**TOWN OF NEWBURGH  
PLANNING BOARD  
TECHNICAL REVIEW COMMENTS**

**PROJECT: MCDONALD'S**  
**PROJECT NO.: 2017-14**  
**PROJECT LOCATION: SECTION 60, BLOCK 3, LOT 41.21**  
**REVIEW DATE: 13 OCTOBER 2017**  
**MEETING DATE: 19 OCTOBER 2017**  
**PROJECT REPRESENTATIVE: CORES STATES GROUP/ ALAN D. ROSCOE, P.E.**

TITLE: SITE PLAN	SHEET: LANDSCAPE PLAN	SITE ADDRESS: 1403 Rte. 300 Newburgh, NY, 12550
------------------	-----------------------	---

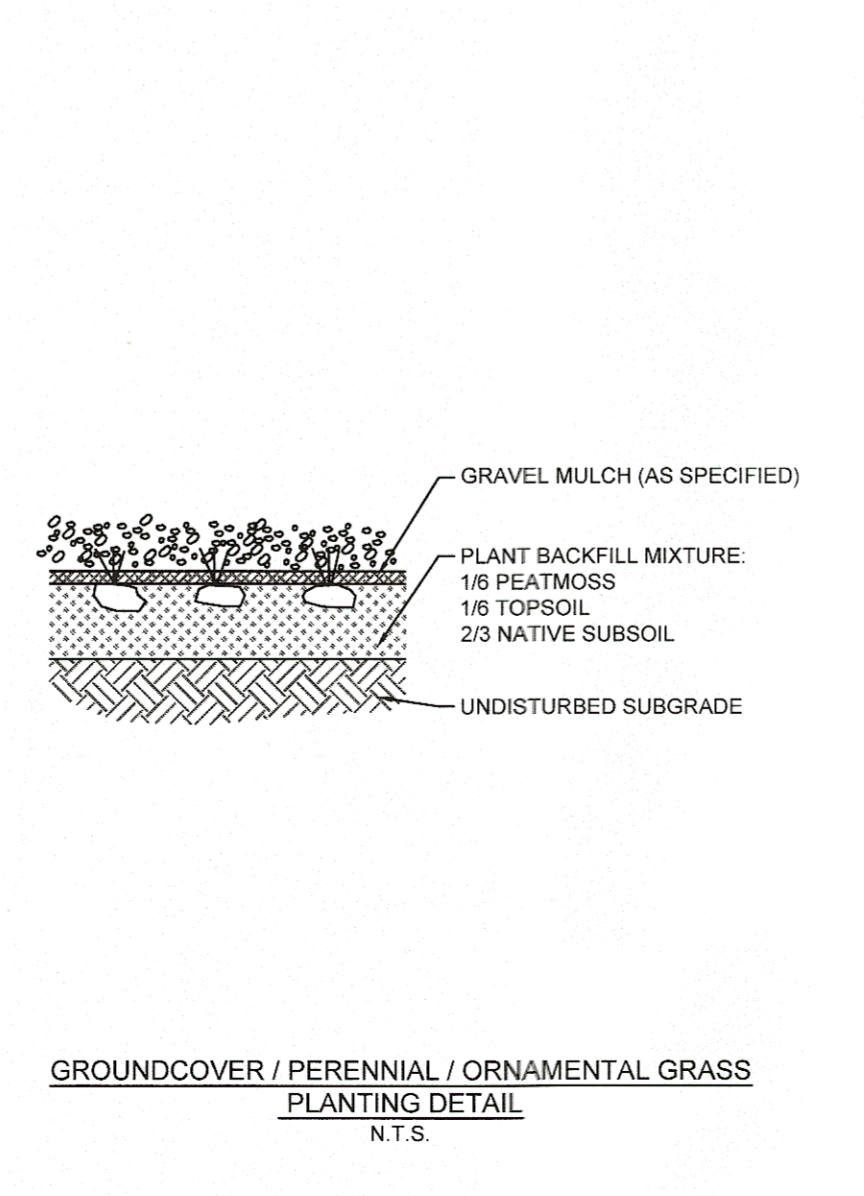
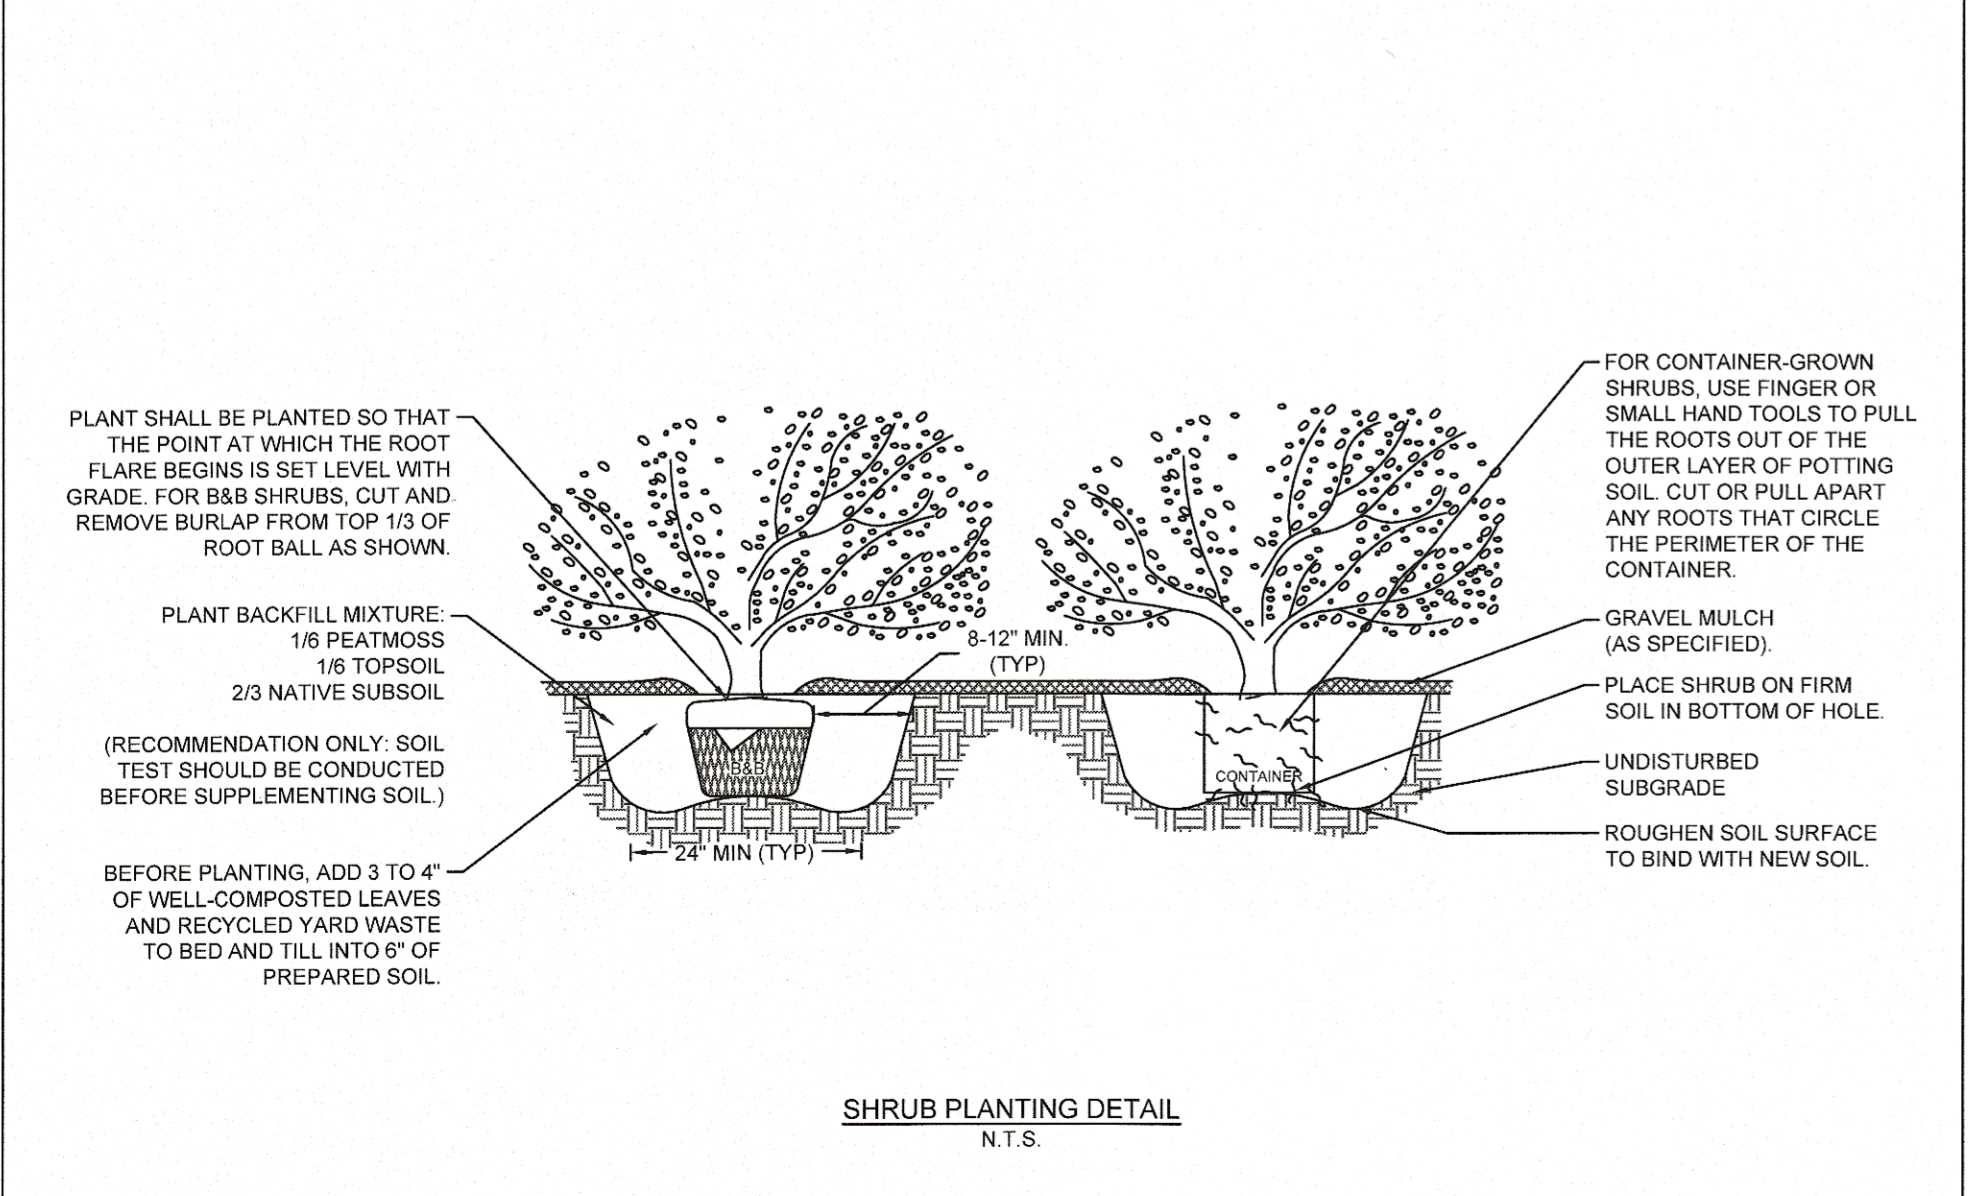
1. A Landscaping Plan has been submitted with a planting schedule. Planning Board should review the proposed landscaping with regard to its acceptability. It is noted that the mature trees on the site are not addressed on the Landscape Plan.
2. Parking lot striping has been revised to comply with Town Codes. Detail of parking lot striping has been added to the plans.
3. Orange County Planning Department review has timed out as of October 9<sup>th</sup>.
